SUMNER-BONNEY LAKE SCHOOL DISTRICT SUMNER HIGH SCHOOL ADDITION - PHASE 2 VALUE ENGINEERING REPORT SEPTEMBER 12, 2025

Revised 10/13/2025 with updated Implementation Data

This value engineering (VE) report is presented to Sumner-Bonney Lake School District and the design team to support decision making at the design development phase for the Sumner High School Addition - Phase 2 project.

North courtyard with planned drainage system

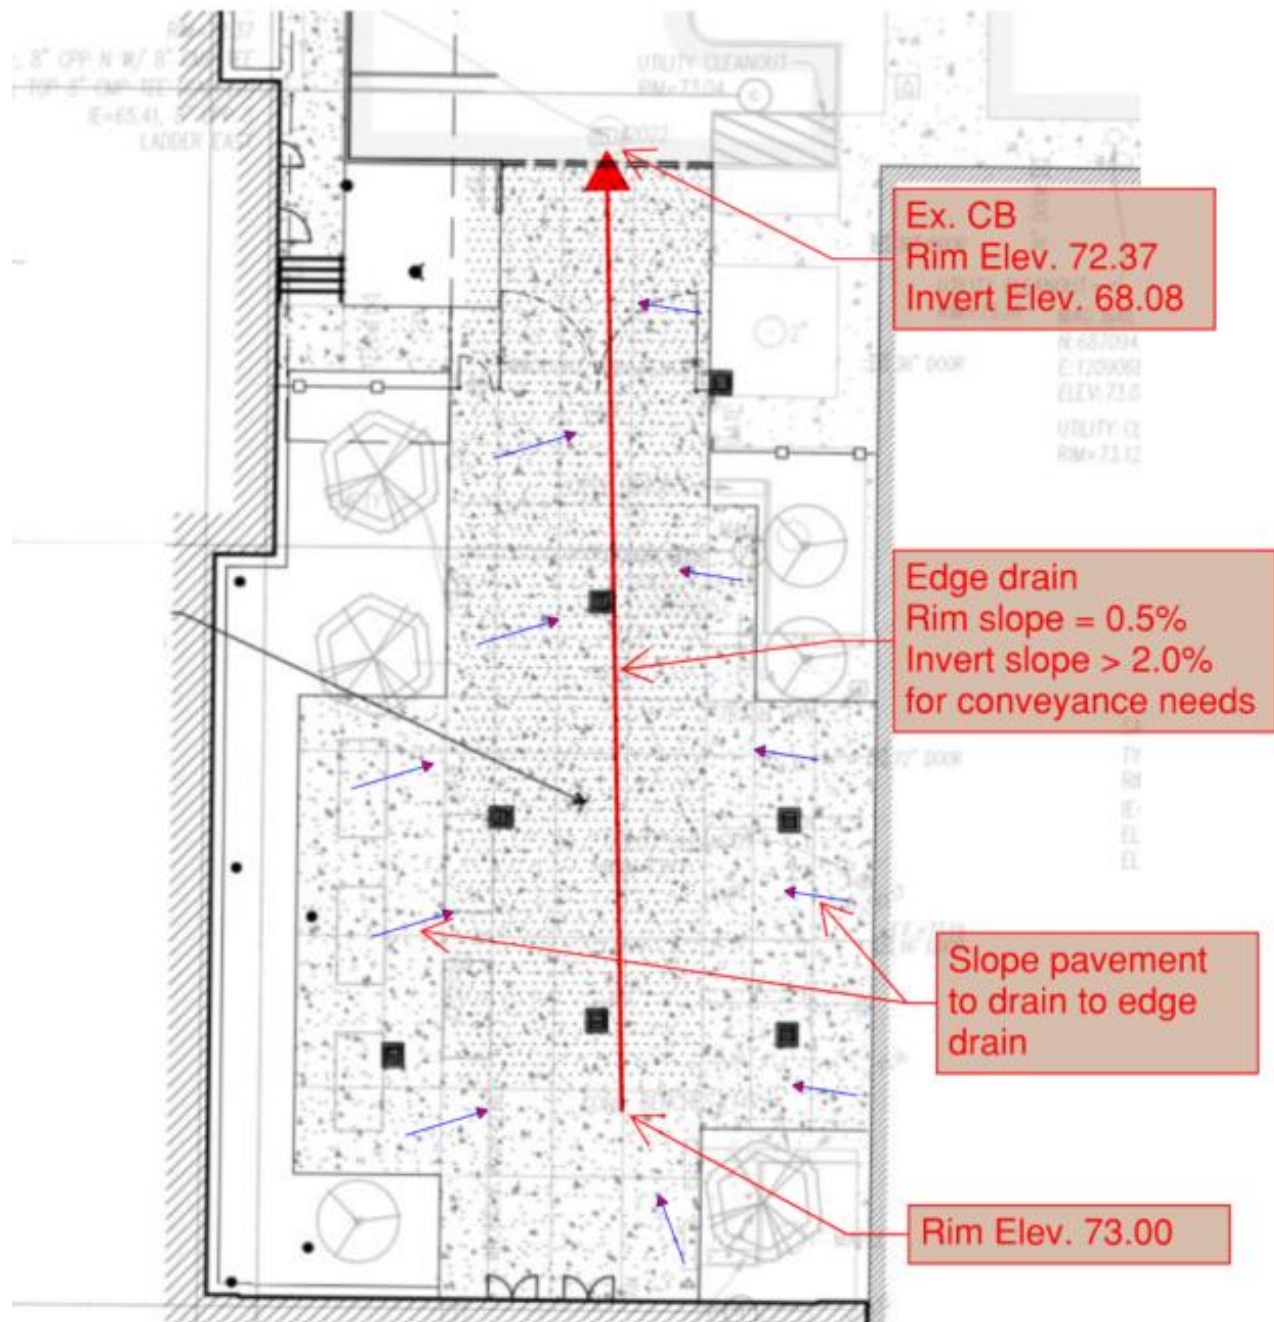
One of the greatest challenges with courtyards is draining a semi-enclosed area adjacent to buildings. Providing an overland flood route provides a way for storm water to drain the courtyard, away from buildings. Otherwise, if an underground storm pipe becomes blocked, stormwater could back up and flood adjacent buildings. An edge drain along with courtyard grading can provide drainage to the existing catch basin located at the north end of the courtyard and an effective flood route system.

Edge drain centrally located in north courtyard drains to existing catch basin to the north

Existing north and south courtyards with concrete pavement

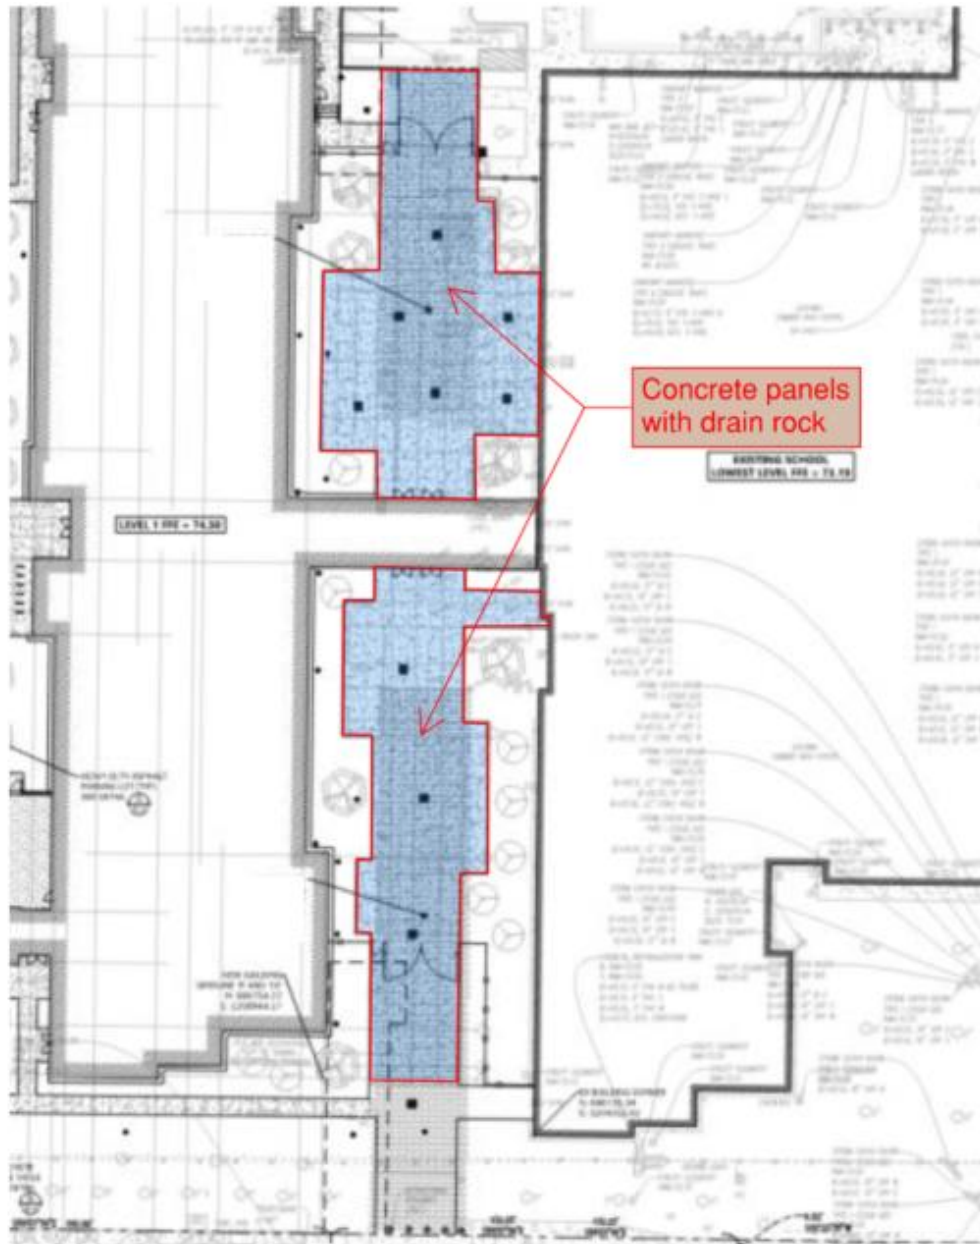
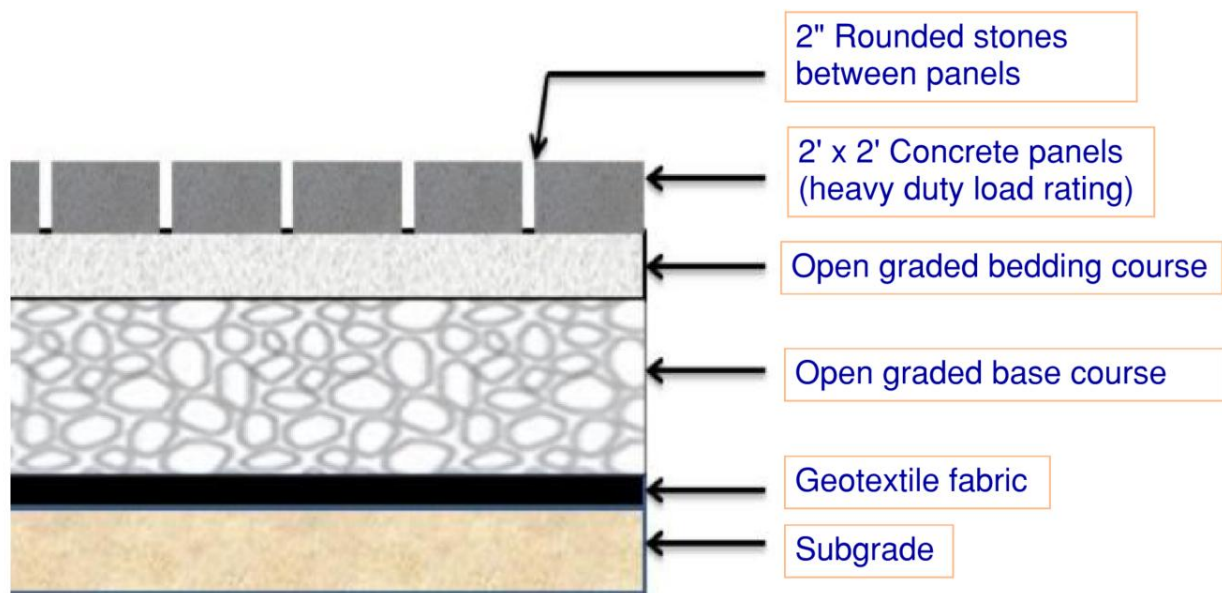
A concrete panel with drain rock system in the courtyard will enable stormwater to drain into the ground. Catch basins and pipes will not be needed to capture and convey stormwater. Larger stones between the concrete panels will be more stable and less susceptible to being kicked out of place, though additional maintenance may be required to replace dislodged stones. However, catch basin and storm pipe maintenance will be eliminated. The concrete panel and drain-rock system can be designed to accommodate the occasional heavy loads of emergency vehicles and still be suitable for ADA accessibility. Surface grading to provide an overland flood route will still be required.

North and South courtyards highlighted for permeable concrete pavers with drain rock

L1	Courtyard Pavement	47,000		X		0	Fora Response: While it would look nice, the proposed material between precast panels would create potential accessibility/egress issues in addition to the maintenance challenges associated with loose material and weeds.
S1	Slab-On-Grade	676,000		X		0	<p>PCS Response:</p> <p>* For seismic base shear resistance and transfer of lateral forces from foundations to subgrade base we rely on fixity at top of piles. Grade beams are working as pile caps and the anticipated fixity will be challenging to achieve with shallower drop caps. Therefore, we would not recommend the change.</p> <p>* We anticipate pile locations to be adjusted on site during construction due to site conditions and evidence of existing timber piles at subgrade. Based on the experience we have from Phase 1, we anticipate 5% - 7% of the piles to be relocated due to potential conflict with timber piles/boulders at the time of construction. Stiff grade beams provide flexibility of piles to be offset from their design location without the need to adjust the steel structure up above during tight construction schedules. This flexibility cannot be achieved with drop caps and therefore we would not recommend the change.</p> <p>* PT slab would limit the flexibility for future T1 projects and increase the risk to damage the foundation system where the repairs would be very expensive. Therefore, we would not recommend the change</p>

BASELINE CONCEPT

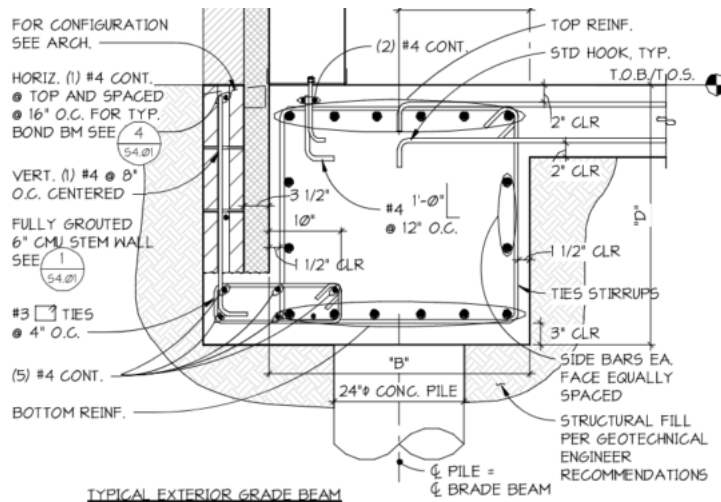
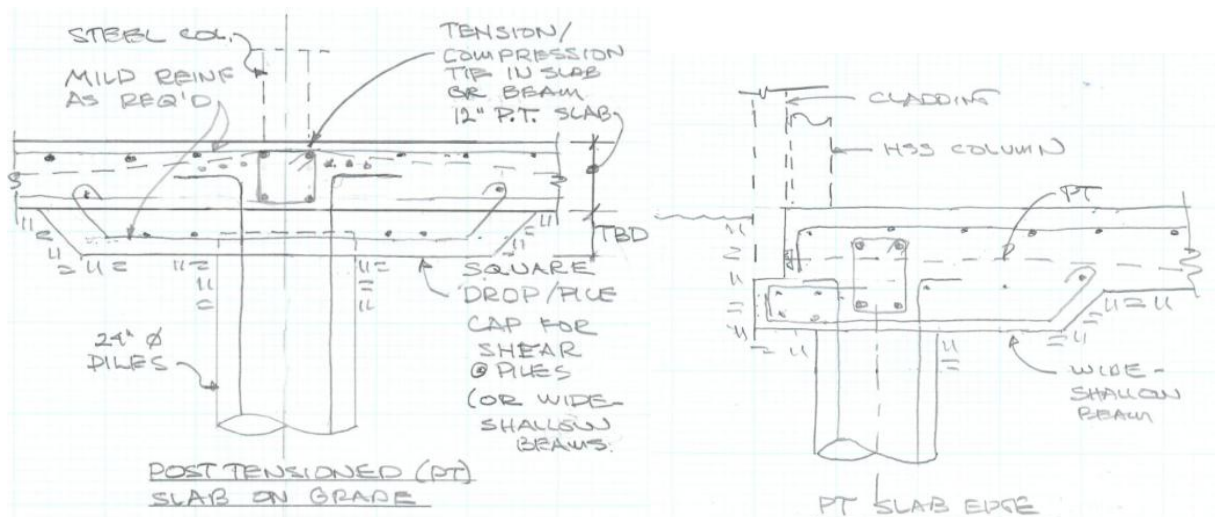
PROPOSAL	S1
COMPONENT: Slab on Grade	AUTHOR	DH
BASELINE CONCEPT: The ground floor slab is 12-inch, mild reinforced, two-way concrete structural slab spanning between large (3' to 4' wide and deep) concrete grade beams supported on auger cast piles.		
VALUE PROPOSAL SYNOPSIS: Replace the mild slab with a two way post tensioned (PT) flat slab with column drops spanning between piles. Replace the tie action provided by the grade beams in the current design with reinforcement embedded in the PT slab and drop caps.		
SCHEDULE SAVINGS: Improved		
QUALITATIVE BENEFITS:		
RELIABILITY	M&O	FUNCTIONALITY
Maintained	Improved	Improved
FUNCTIONS:		
Support Loads	Stabilize Structure	Control Moisture
ADVANTAGES: <ul style="list-style-type: none"> Improves Schedule Reduced Excavation Reduced interference with utilities Improved subgrade drainage Reduced structural depth 		DISADVANTAGES: <ul style="list-style-type: none"> More Complex Implementation Reduced flexibility for changes Fewer subcontractors qualified for work

Using a PT slab with square drop caps at the columns, or continuous “wide-shallow” beams on the column line may make it possible to reduce the depth of the concrete at the column lines or even eliminate the thickened concrete away from the columns. The PT slab can be designed as a two-way slab with thickened drop cap sections sized to carry the shear forces at the piles. A continuous wide-shallow beam could also be used to provide additional slab stiffness and strength and ease possible congestion of reinforcement and post tensions along column lines. The wide shallow beams could also be used under the braced frames for uplift anchorage and to distribute lateral forces to adjacent piles. Compression and tension tie forces between columns can be carried by reinforced column sections in the PT slab or wide shallow beams.

VALUE PROPOSAL CONCEPT

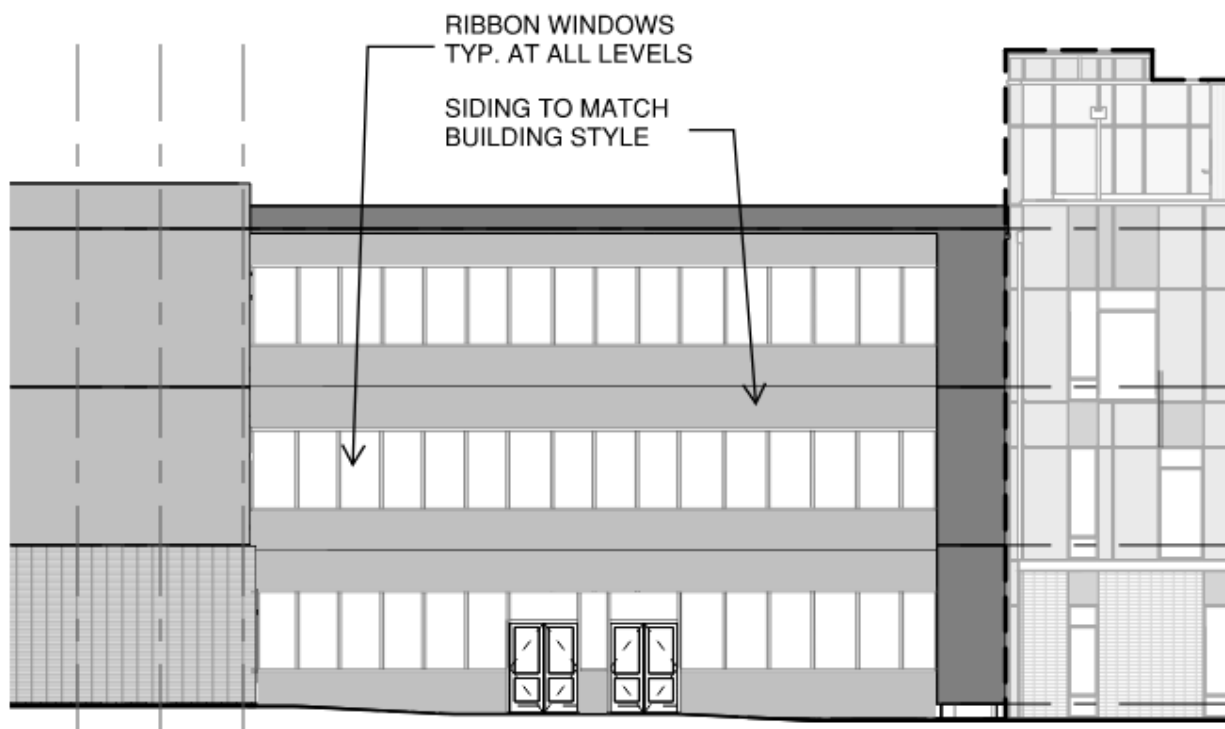
PROPOSAL	A1
COMPONENT: Walkway Glazing	AUTHOR	BC
BASELINE CONCEPT: The design includes a 3-story tall curtain wall cladding system on each side of the connector corridors spanning from the Phase 1 building to the Phase 2 building.		
VALUE PROPOSAL SYNOPSIS: Replace the proposed curtainwall system with ribbon windows and typical cladding.		
SCHEDULE SAVINGS: Maintained		
QUALITATIVE BENEFITS:		
RELIABILITY	M&O	FUNCTIONALITY
Maintained	Improved	Maintained
FUNCTIONS:		
Transmit Light	Define Aesthetics	Insulate Space
ADVANTAGES: <ul style="list-style-type: none"> Improved Maintenance Improved Energy Efficiency Decreased Construction Costs 		DISADVANTAGES: <ul style="list-style-type: none"> Re-design required Changes Aesthetic Reduces Transparency

A primary concern was brought up during the review relative to transparency. A major driver of the curtain-wall system in the original design proposal is to provide as much openness and transparency as possible. This alternate proposal includes less glazing however it attempts to maintain as much openness and transparency as possible by keeping an uninterrupted linear expanse of glass.

VALUE PROPOSAL CONCEPT

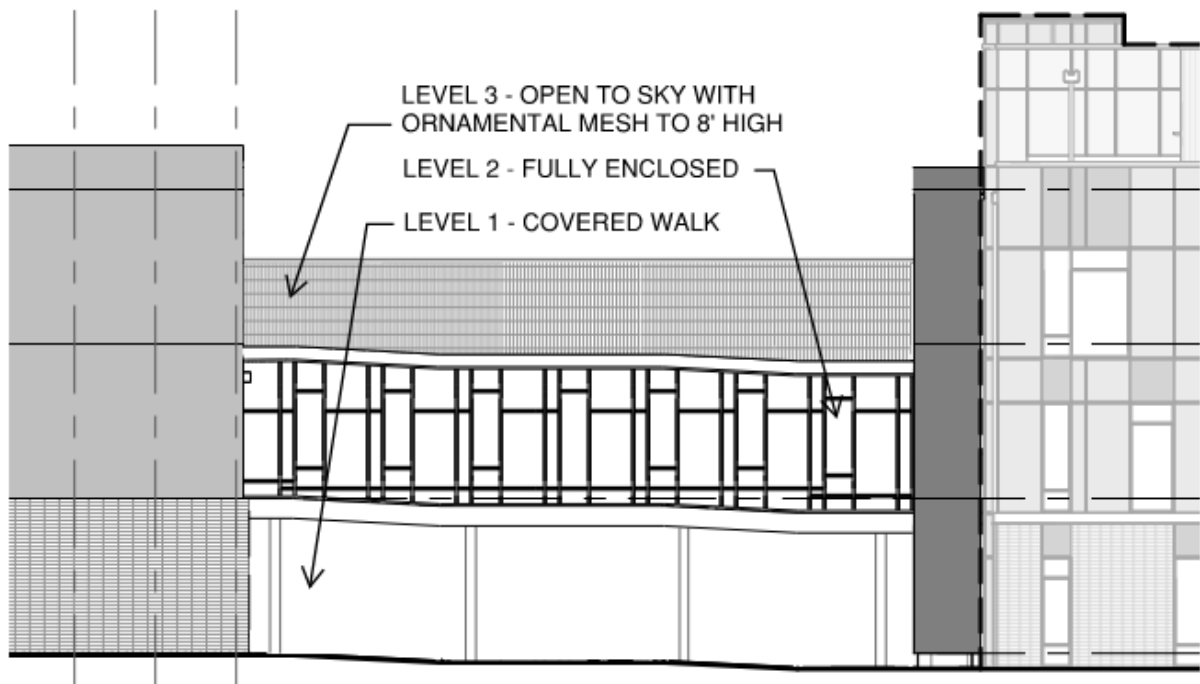
There was some discussion relative to the potential for student safety and possibility of hanging unapproved banners etc. over the edge of the 3rd floor open walkway. An 8' tall metal mesh screen is proposed to mitigate this issue. The possibility for pre-approved banners to be temporarily installed could add some value to this configuration.

Two 2-way valves (left); four-pipe run-out to active beam (right).

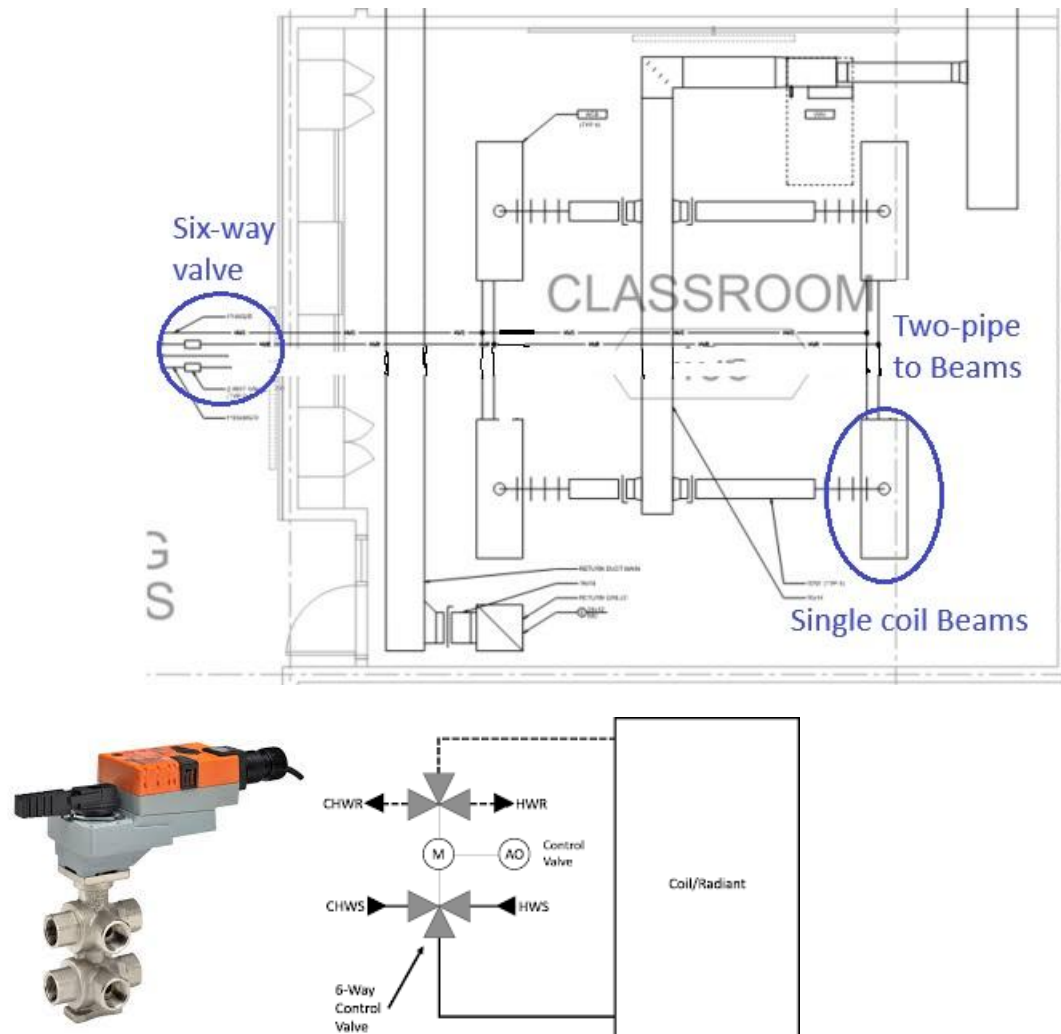
Was not aware of six-way valve technology and expressed interest in reducing project cost and complexity but were concerned about added complexity or additional maintenance staff training, due to difference from the Phase 1 building.

Six-way valve (left); two-pipe runout to active beam (right).

M2	Hydronic Distribution	440,000		X		0	Metrix Response: Preliminary Metrix cost opinion suggests a credit for this is roughly \$130,000, not the indicated \$440,000. The current design of (2) 2-way valves matches the approach of Phase 1. 6-way valve control adds complexity not only in how the valve functions, but also because the sequence of operation for phase 2 chilled beams will not match phase 1. 6-way valves are also harder to maintain/troubleshoot because of the increased complexity.
M3	Water Distribution	94,000			X	31,330	Metrix Reponse: Domestic water pipe routing to be revised to reflect the more vertical approach proposed. Some areas of the building will remain as drawn because a vertical approach does not save pipe, therefore the full credit will not be realized.
E1	Panel Boards	71,000			X	35,500	Hargis Response: Suggested panelboard topography is reasonable and will be applied specifically for smaller (low relative load) science rooms and lab spaces. We will not plan on utilizing this approach for the lab spaces with larger equipment and programmtic electrical loads. Proposed unit cost (cost savings) of surge protectors is 3-4x normal SPD costs. Realized value savings somewhat less than proposed.
